Horsham District Cycling Forum: Comments to the Inspector on Documents REP/847002/007A & 007B- PBA Transport, Infrastructure and Flood Risk

Option to reduce traffic on Rusper Rd, and increase sustainable transport use by improving conditions for cycling.

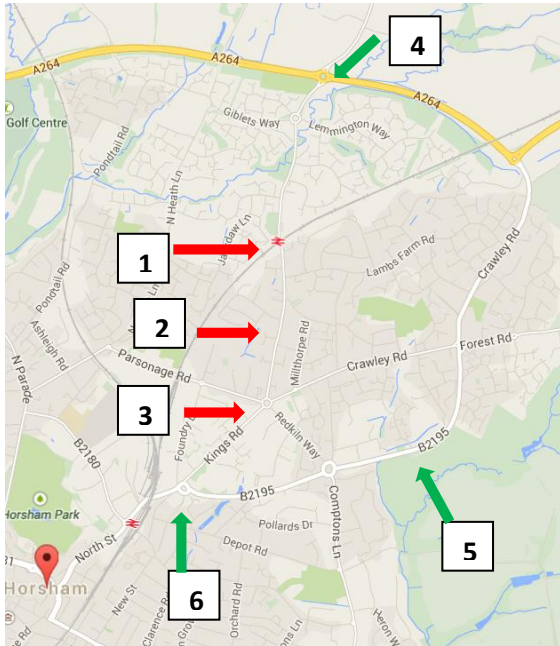
Problems with proposed Rusper Rd route for cars:

1. Level crossing slows journey
2. Many side roads and properties fronting road
3. Roundabout above capacity without widening

Alternative:

4. Restrict vehicle access at Rusper Rd roundabout
5. Route traffic via faster Harwood Rd, B2195
6. Routes meet
